The Ted, Dun Laoghaire, Built to Rent

Stormwater Audit Stage 1

Document Number: 202119-SWA-S1

designed by	author	scale	sheet size
PCC	BS	1:50	A1
drawing no.	revision		
TED-DBFL-SW-SP-DR-C-3311	P01

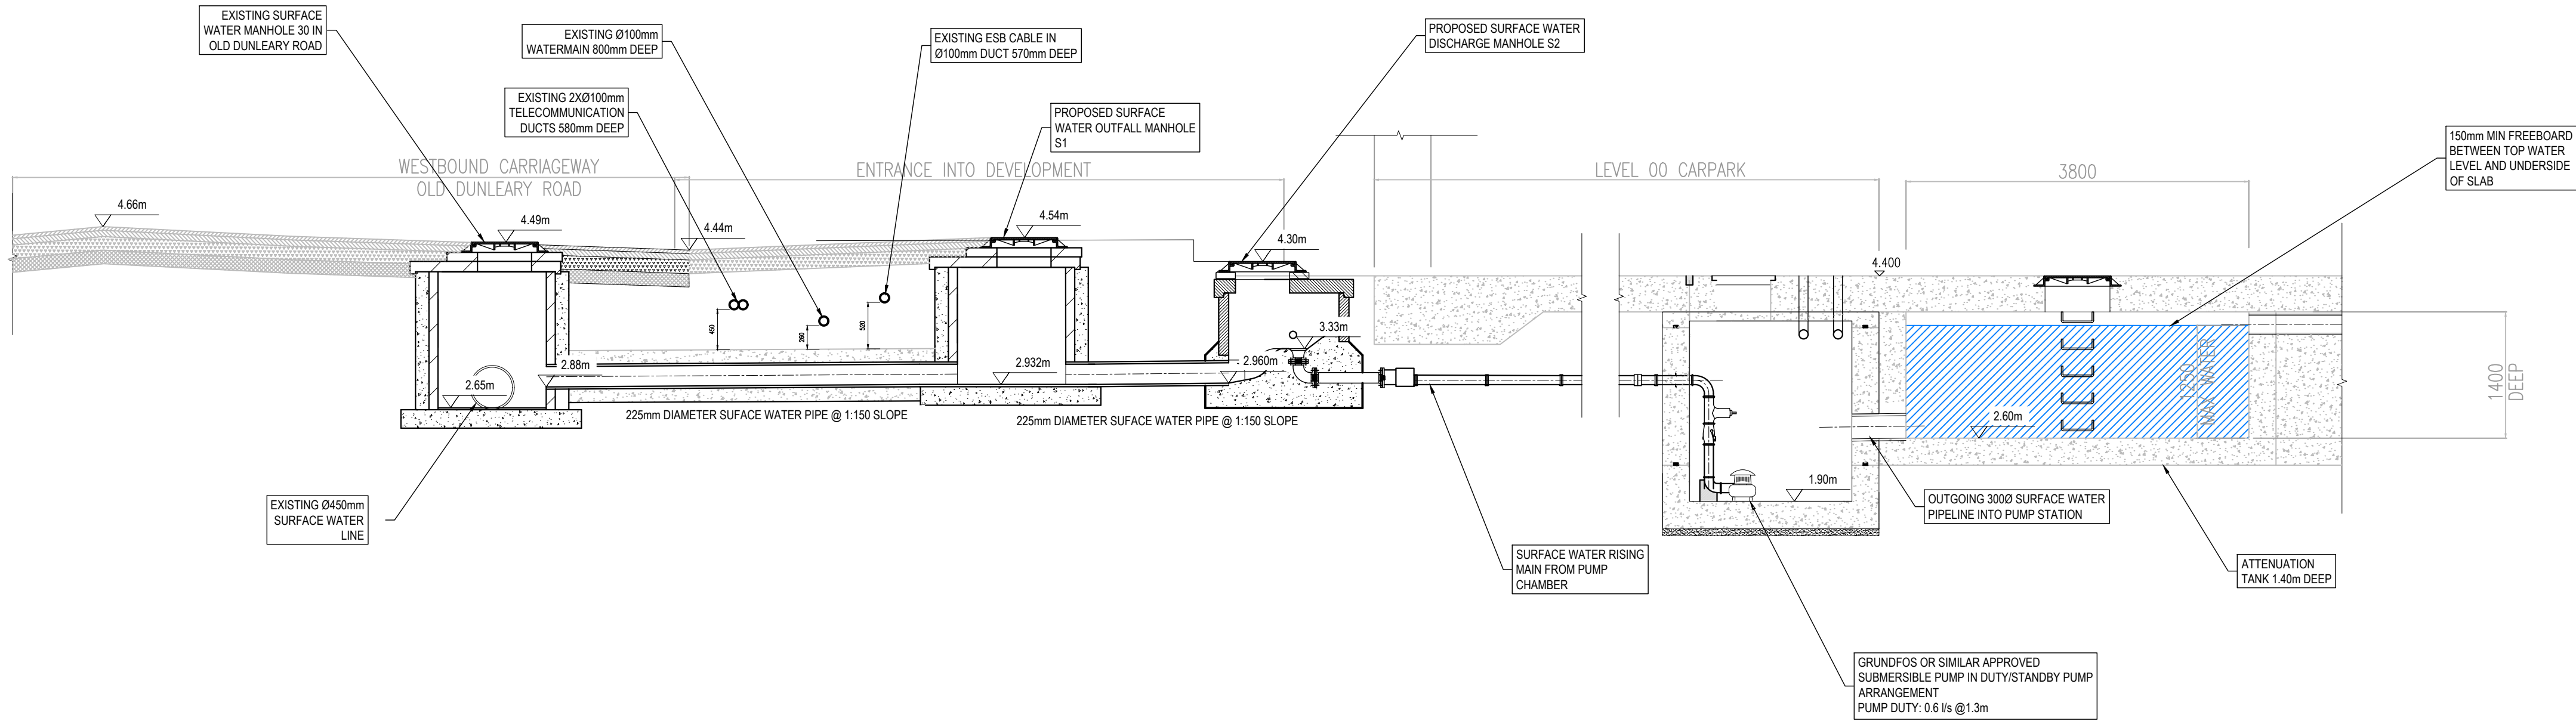
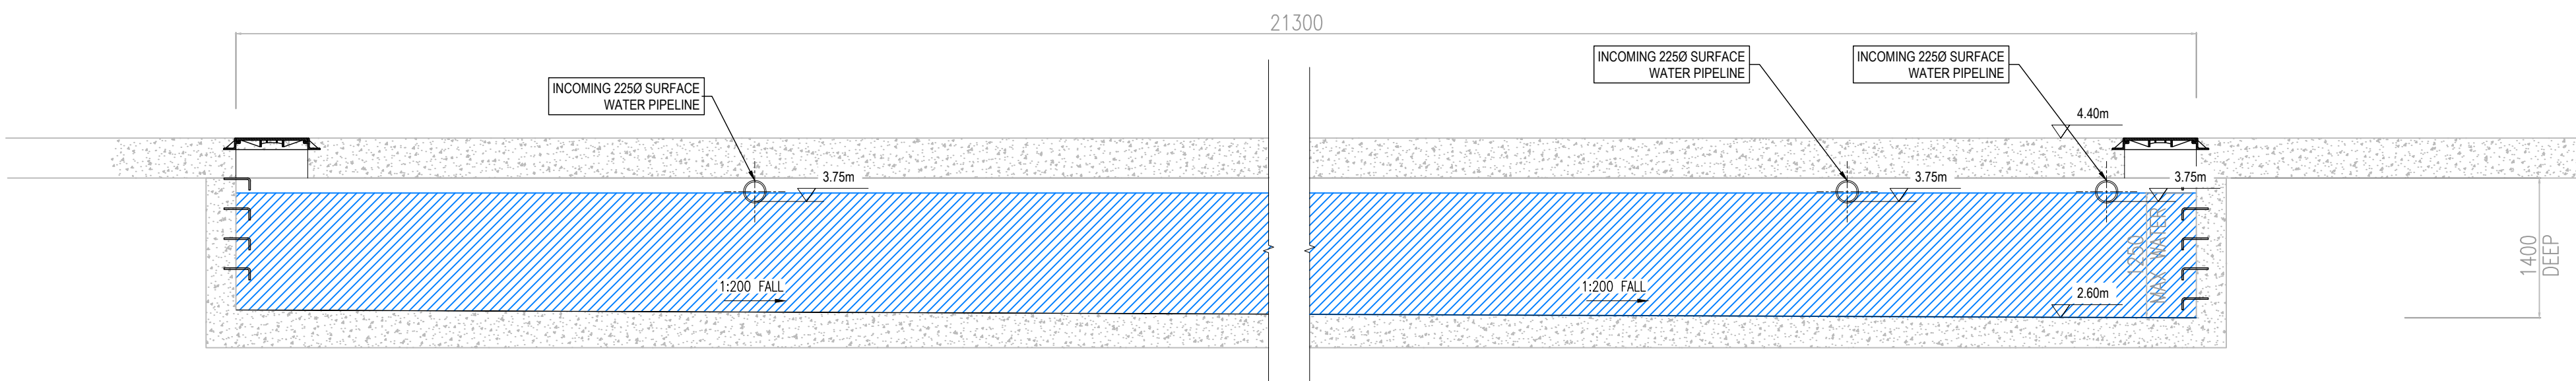
Problem: The current surface water outflow from the attenuation tank is pumped to a discharge manhole which then outfalls to the existing public sewer. Pumped systems should be avoided if possible as they can be prone to failure.

Recommendation: Reconsider a gravity outfall option.
